DRAFT
EN 15193-1:2017
prA1

Energy performance of buildings - Energy requirements for lighting - Part 1: Specifications, Module M9

This amendment 1 is processed to provide a method for estimating the daylight supply for sloped roofs. This method was still under development during the drafting of EN 15193-1:2017.

1 Modifications to Annex F, Daylight availability

F.5 Daylight supply factor for windows in sloped roofs

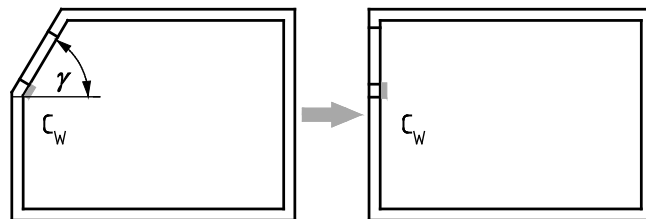
In the case of rooms with windows in sloping roofs, the rooms being considered have to be adapted to equivalent rooms with either vertical façade windows or roof lights. The deciding factor for this is the roof slope angle. The roof slope angle is measured with respect to the horizontal.

Figure F.10 — Adaptation to vertical facade
(standards.iteh.ai)

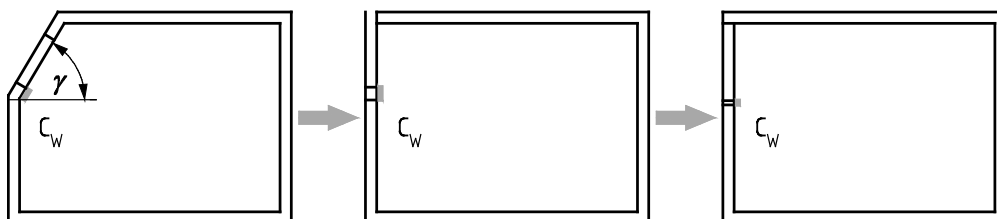
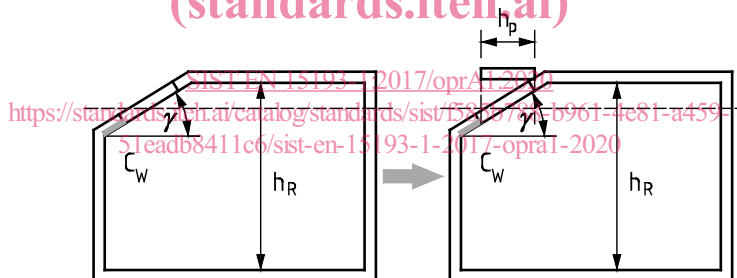
- For roof slope angles larger or equal to 75 degrees the EN 15193-1 model for vertical façade windows shall be used.
- For slope angles smaller than 75 degrees the EN 15193-1 model for roof lights shall be used after a geometric adaptation of the room height and the window size in the equivalent room.

The diagrams in Figure F.10 and Figure F.11 show the process for the adaption of the room height and the window size for these two possibilities.

a) The window is rotated to the vertical and fits without further adjustment

b) The window is rotated to the vertical but then protrudes above the ceiling of the room. C_w is reduced until the window fits within the room

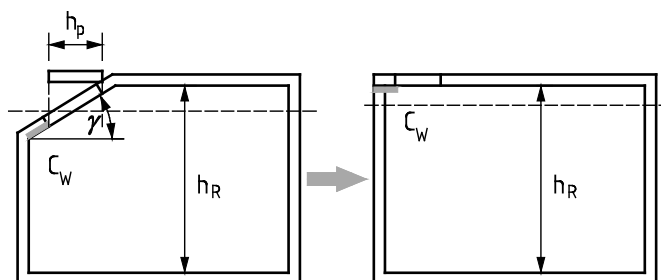
a) The window height is adjusted to h_p , the projected height of the window in the horizontal plane

b) The resized window is rotated to the horizontal
